# Montgomery County Historic Preservation

## Staff Report

<p><b>ADDRESS:</b> 46 Grafton Street, Chevy Chase, Chevy Chase</p> <p><b>RESOURCE:</b> Chevy Chase Village Historic District</p> <p><b>APPLICANT:</b> Doug and Mary Beth McDaniel</p> <p><b>REVIEW:</b> HAWP</p> <p><b>CASE NO.:</b> 1158773</p> <p><b>PROPOSAL:</b> Retroactive fence installation</p>	<p><b>MEETING DATE:</b> 6/10/2026</p> <p><b>REPORT DATE:</b> 6/3/2026</p> <p><b>PUBLIC NOTICE:</b> 5/27/2026</p> <p><b>TAX CREDIT ELIGIBLE:</b> No</p> <p><b>STAFF:</b> Devon Murtha</p>
---	--

Figure 5: View of the subject property from the Grafton Avenue (Googlemaps) with the approximate location of the district boundary indicated in yellow.

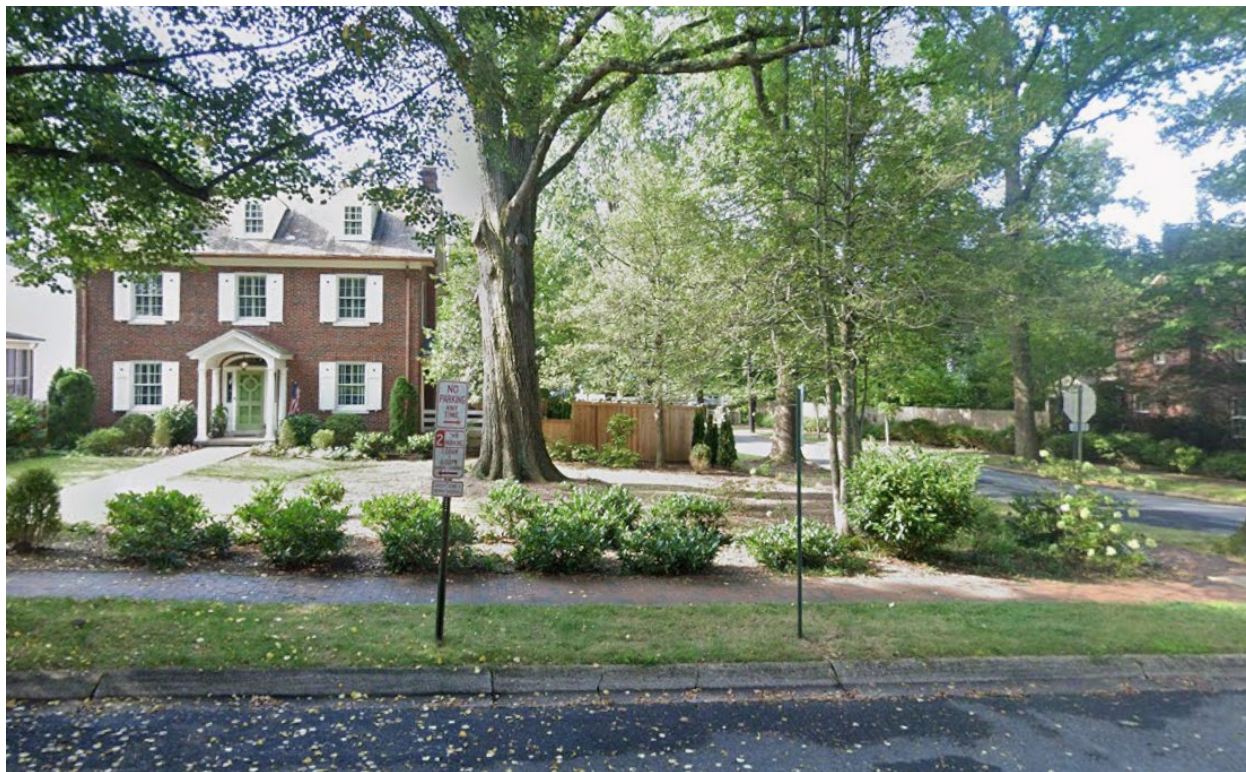
Staff finds that the small section of picket fence that was replaced with four-foot (4') solid board is somewhat atypical. Generally, fences in the front yards of the Chevy Chase Village Historic District are low picket fences, and not solid board, to maintain the patterns of open space, per the *Design Guidelines*. However, Staff finds that this small section of board fence will not have a meaningful impact on the overall streetscape. The four-foot section of fence is recessed substantially in the front-yard, nearly to the front plane of the house. The fence encloses side yard and does not encumber the view of the façade in any way (*Figure 5*).
